APPENDIX B
POST-DR II DESIGN CHANGES

Oregon Square
November 5, 2015

CAMPUS COMMENTS TO ADDRESS - POST DR II

People's Gate – Add Element to Reinforce Character

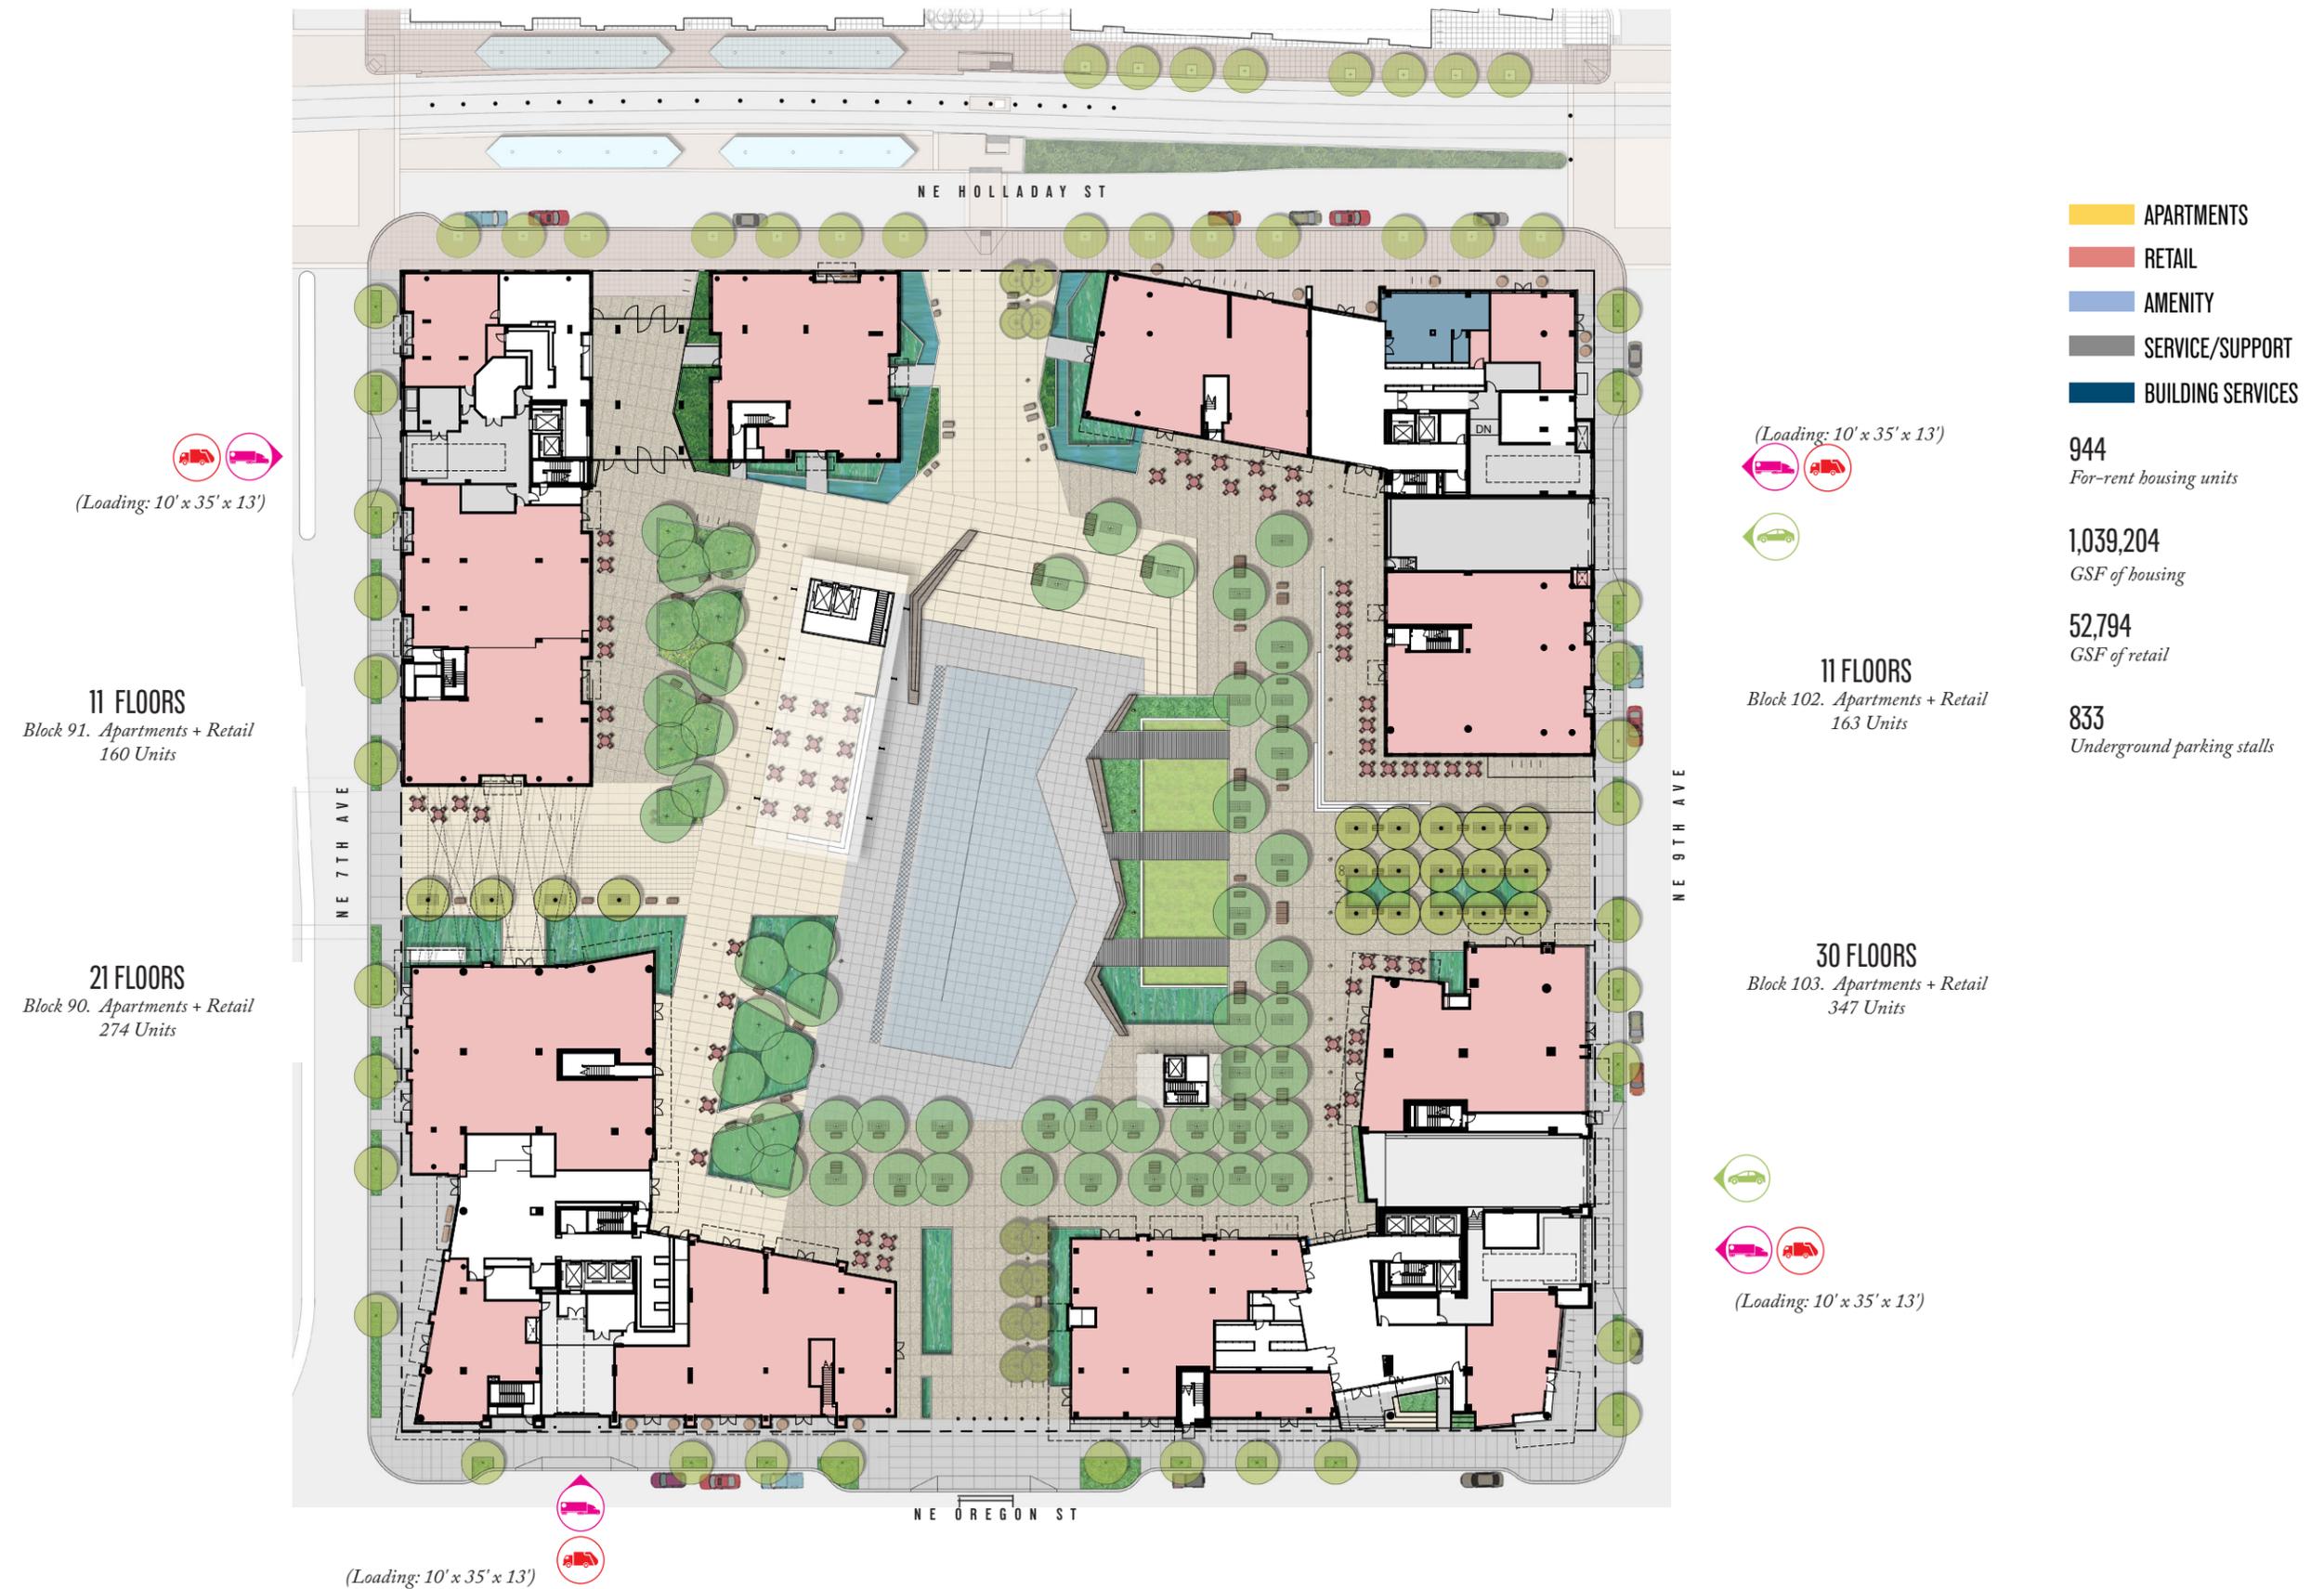
For the People's Gate, something, not necessarily art, is needed to strengthen the role/name of the gate similar to the others 3 portals.

GBD: South Portal – while preserving fire access, we will see what other solutions might address this comment.

ENTRY GATES : FOREST GATE (EAST)

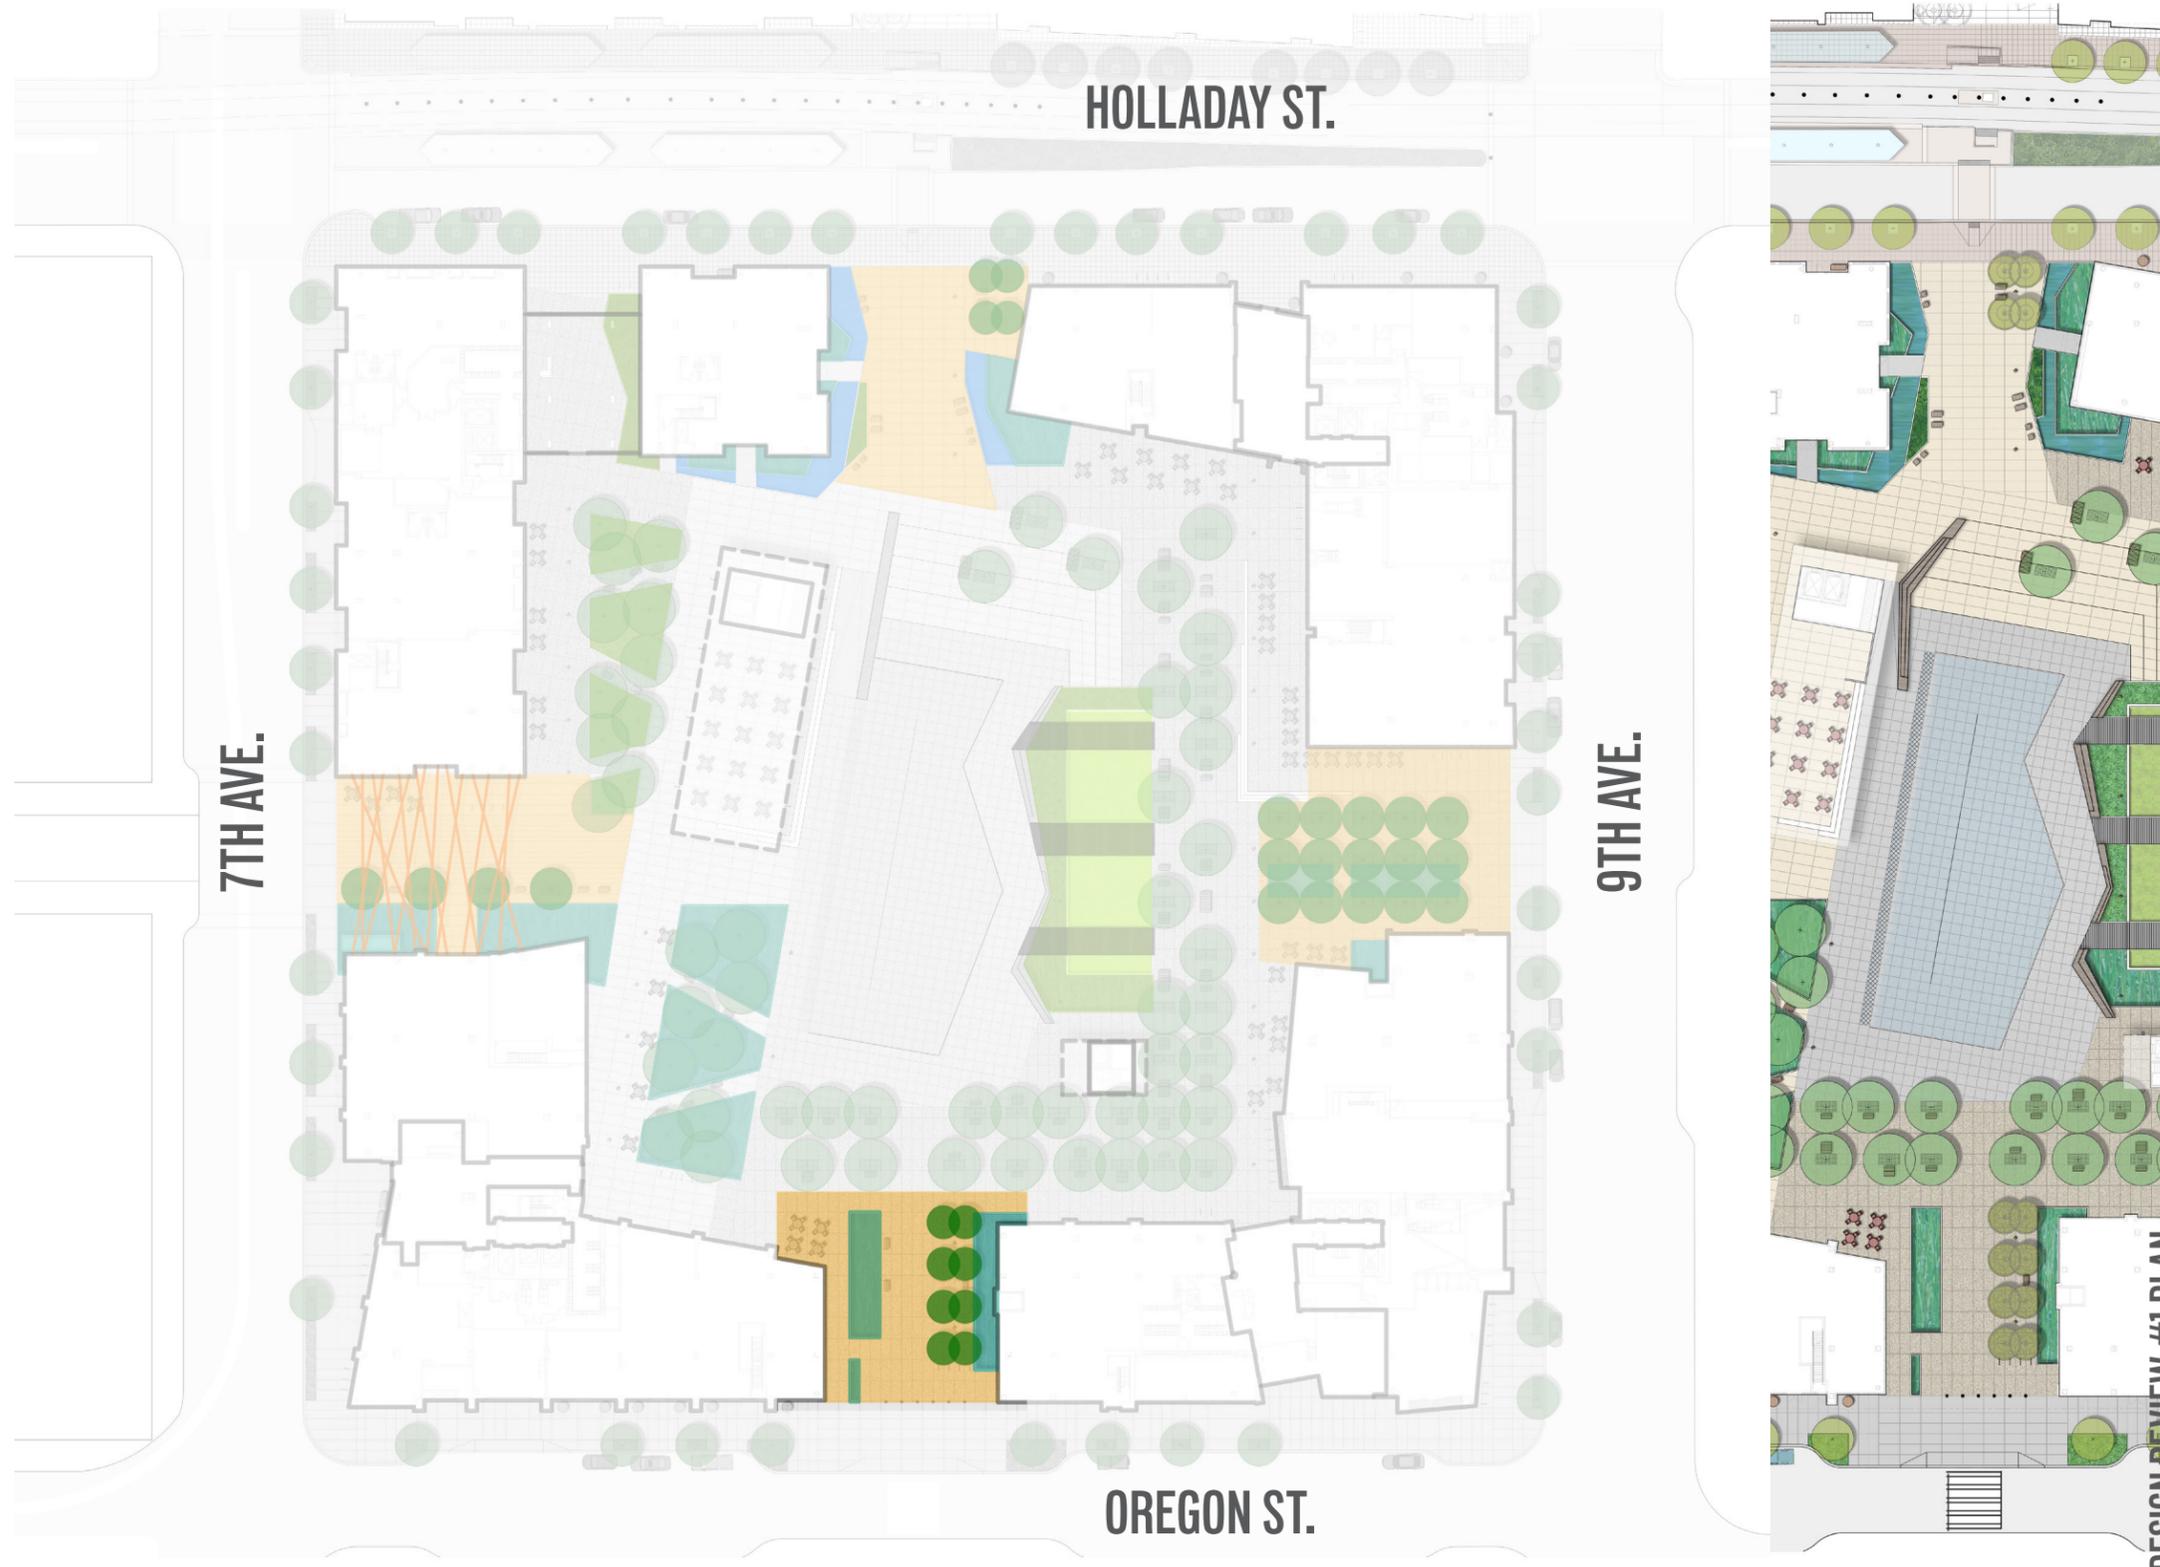
With additional specimens to increase the tree density, the revised design of the east gate takes a stronger stand towards creating a sense of cover and emphasize the pedestrian corridors.

The stormwater planters at the center of the space allow for the building fronts to be open to pedestrian traffic and spillout zones.

ENTRY GATES : PEOPLE'S GATE (SOUTH)

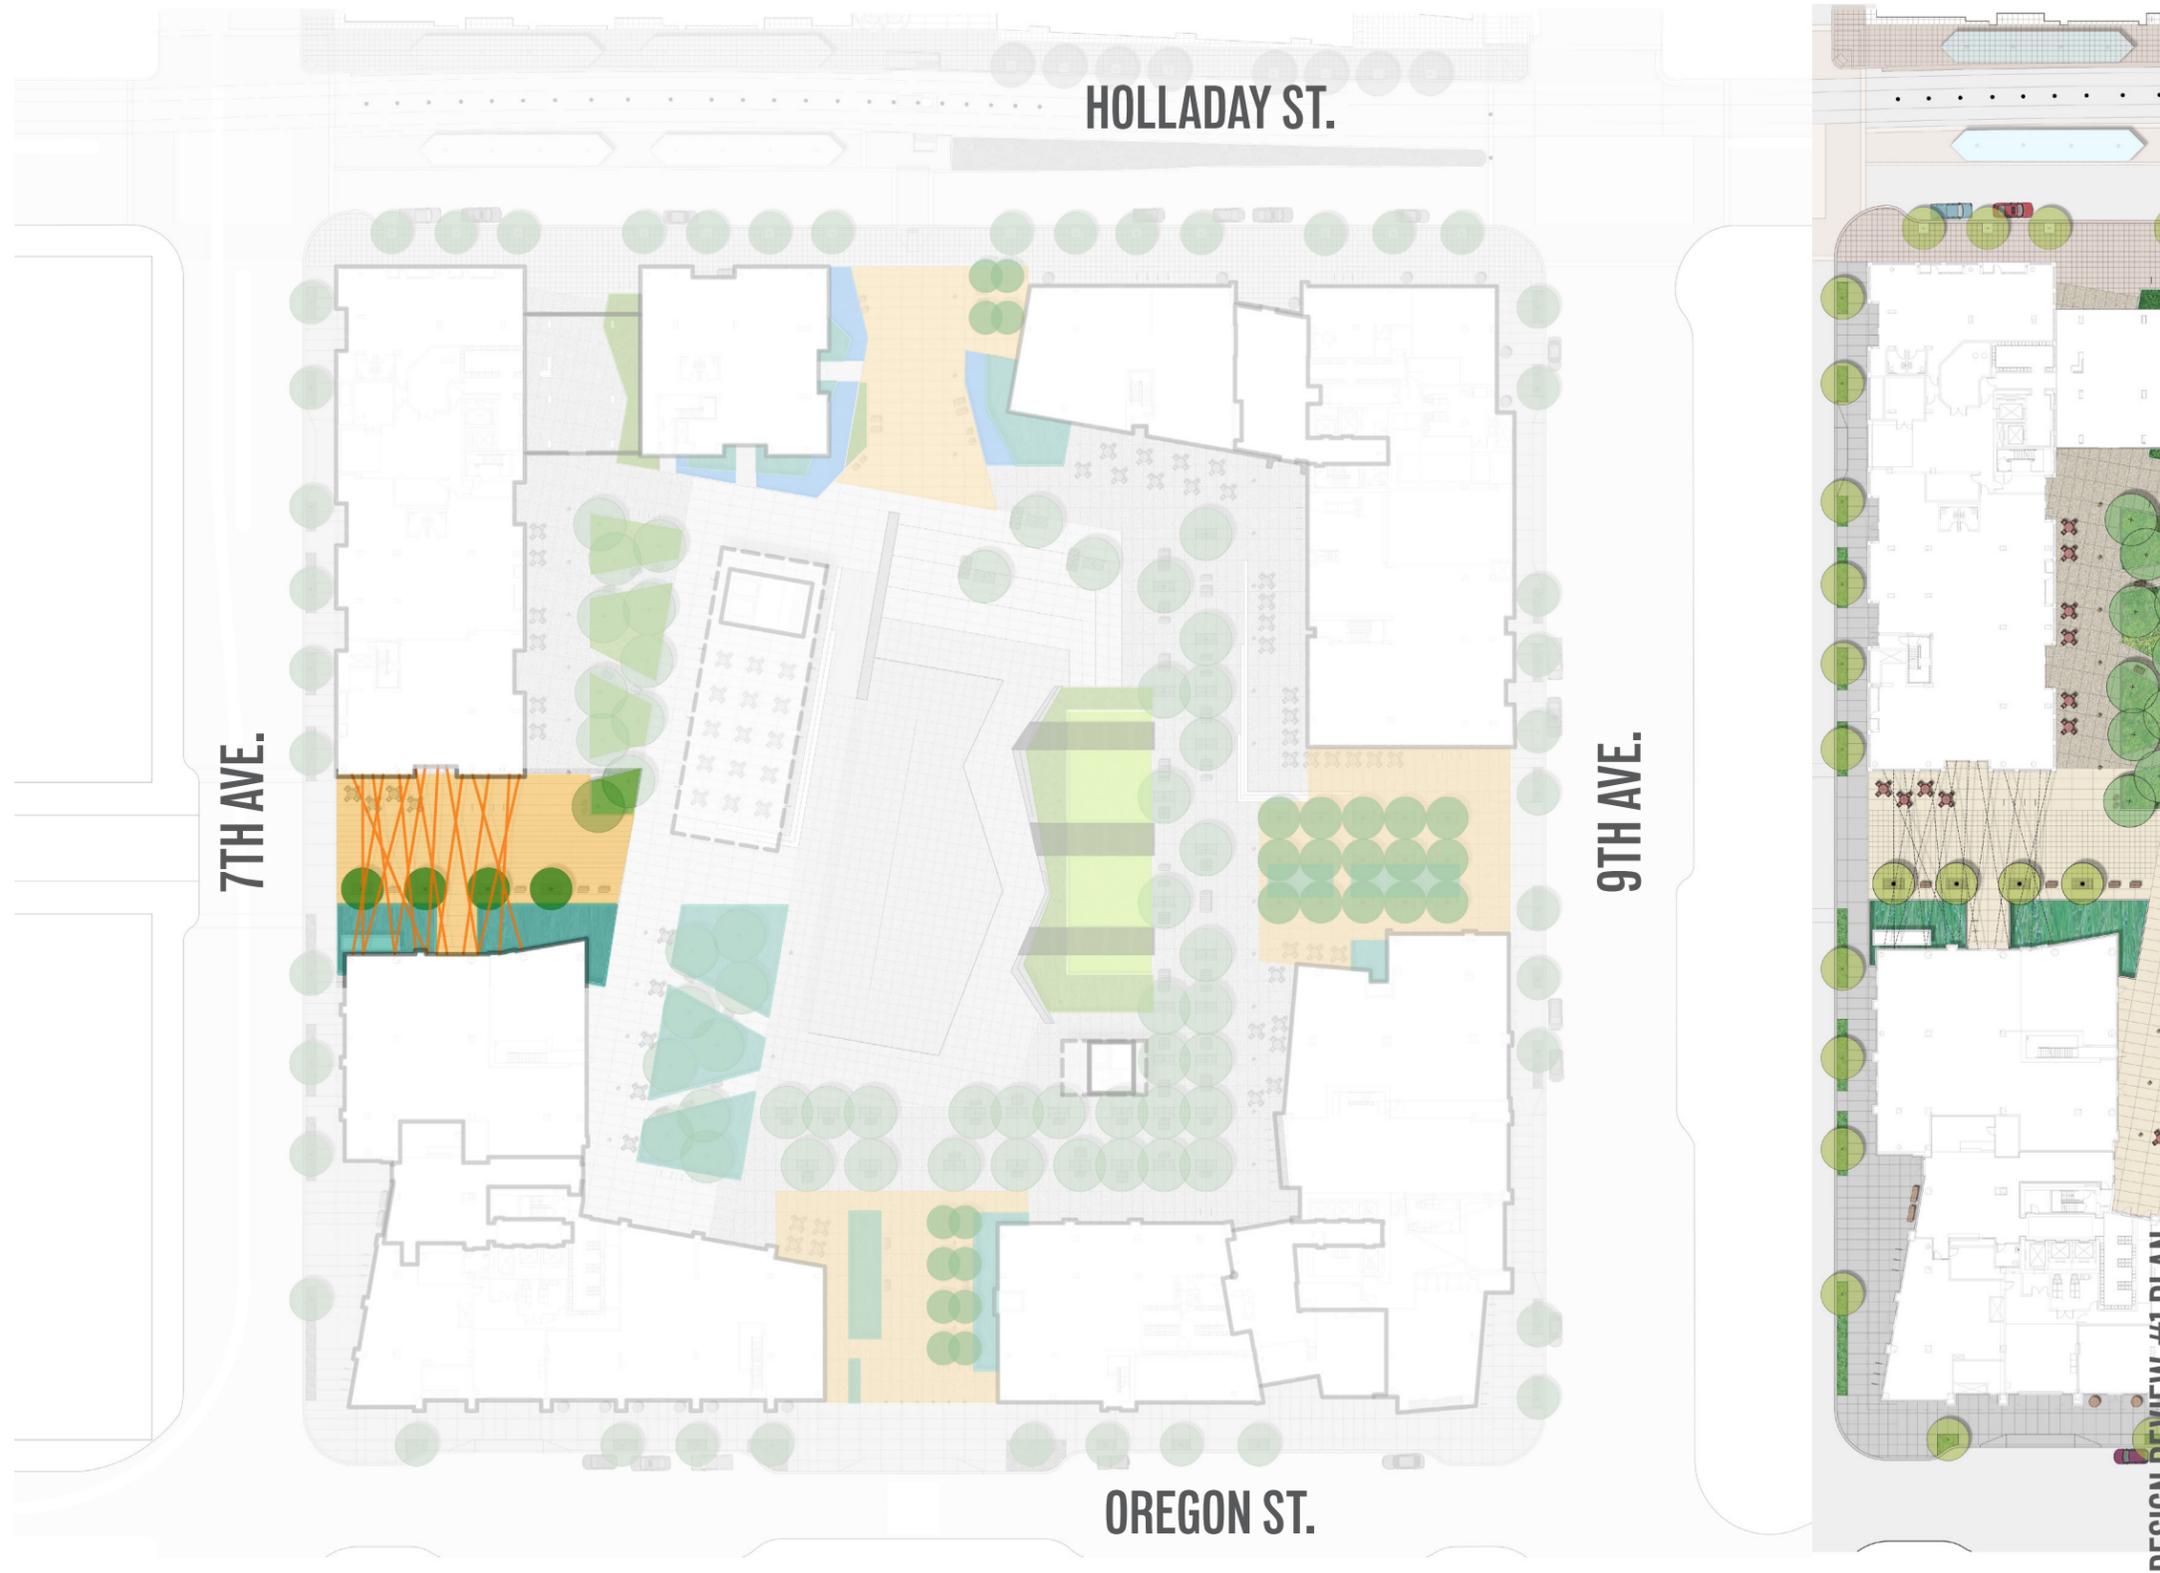
The adjustment on the South gate uses a variant arrangement of the same elements. These elements include storm water planters, trees and furnishings, and incorporate a more pedestrian scale while allowing for service vehicle access.

The storm water planters on the West side are now detached, allowing for direct access to the building retail front and corners.

The design of the storm water planters has also been simplified in its lines.
